GEOTECHNICAL INVESTIGATION ORLEANS LEVEE DISTRICT PONTCHARTRAIN BEACH FLOODWALLS AND LEVEES NEW ORLEANS, LOUISIANA

ADDENDUM NO. 4
Pontchartrain Beach
Flood Protection Improvement Project
Phase II
Proposal No. 2040-0375
Lakefront Capital Improvement Program
The Board of Levee Commissioners
of the
Orleans Levee District
January 28, 1987

ADDENDUM NO. 1
Pontchartrain Beach
Flood Protection Improvement Project
Phase II
Proposal No. 2040-0375
Lakefront Capital Improvement Program
The Board of Levee Commissioners
of the
Orleans Levee District
January 22, 1987

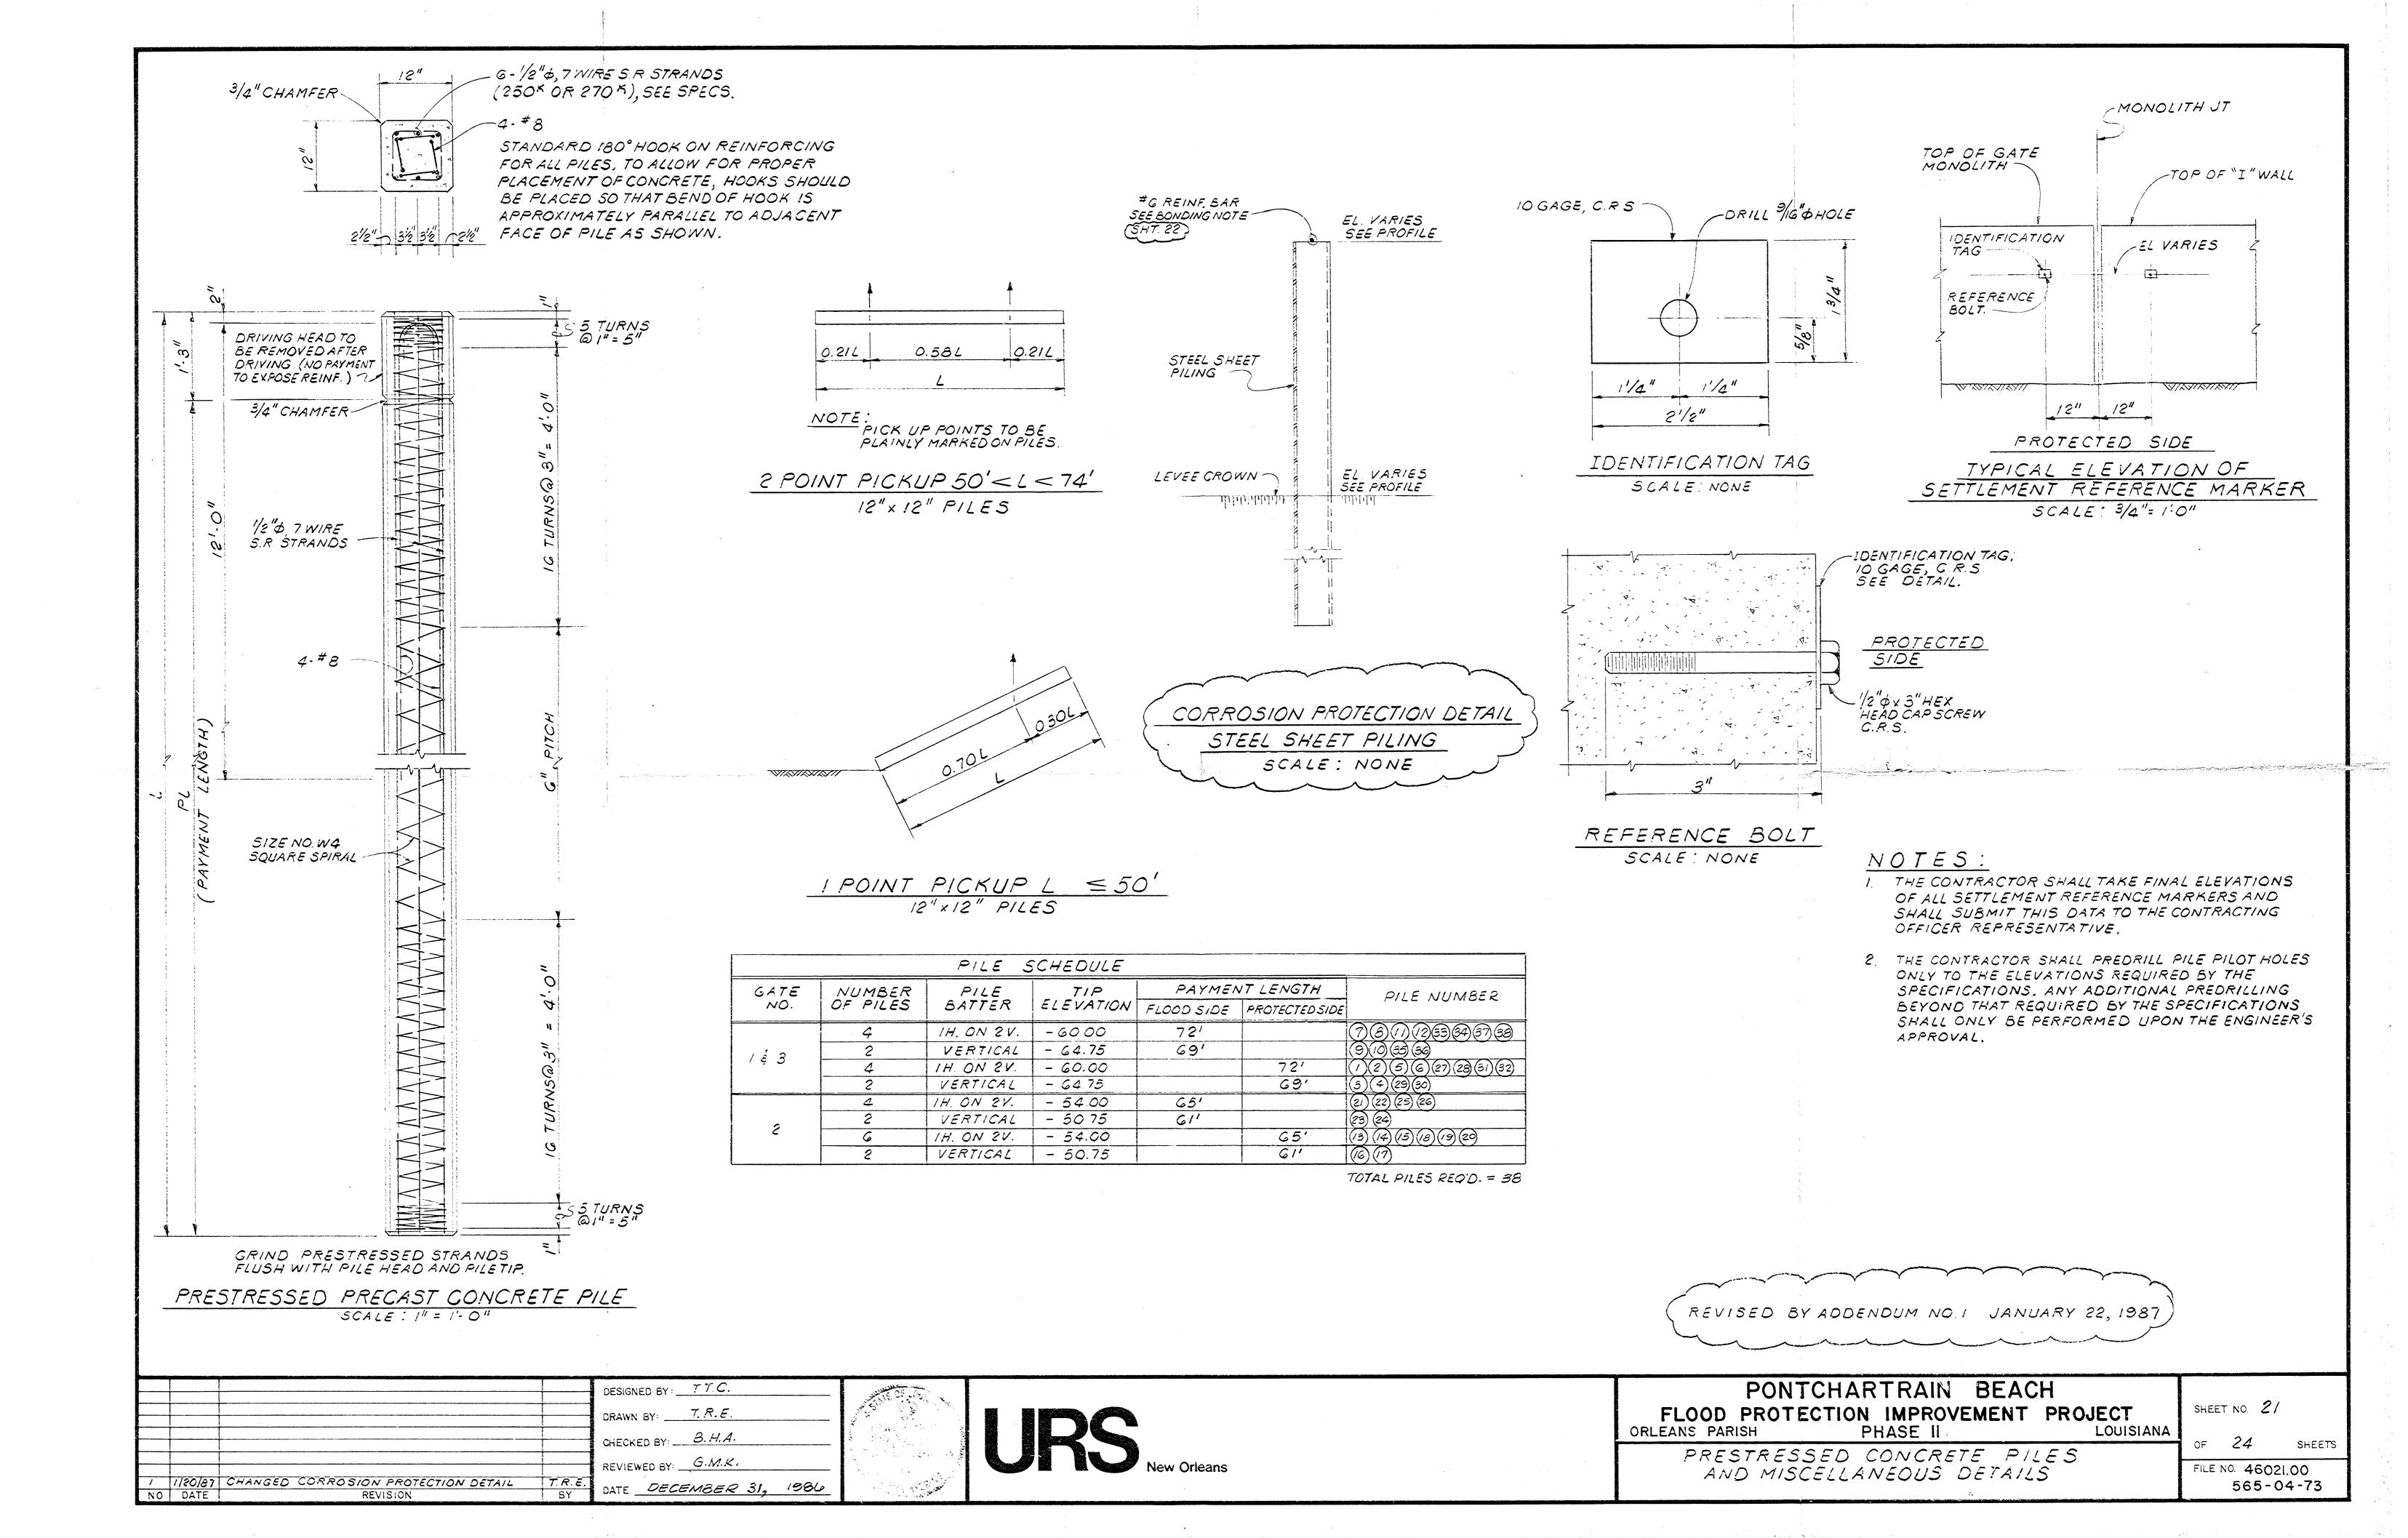
- 10. Replace sheet 21 of the project drawings with the enclosed sheet 21 as revised by this Addendum No. 1.
- 11. Refer to Item B-4.03 <u>Interpretations</u> (page D-2) of the Instructions to Bidders of the specifications. In the last sentence therein, change the last sentence to read as follows: "Questions received less than seven (7) calendar days (including weekends and holidays) to the time for opening Bids will not be answered".
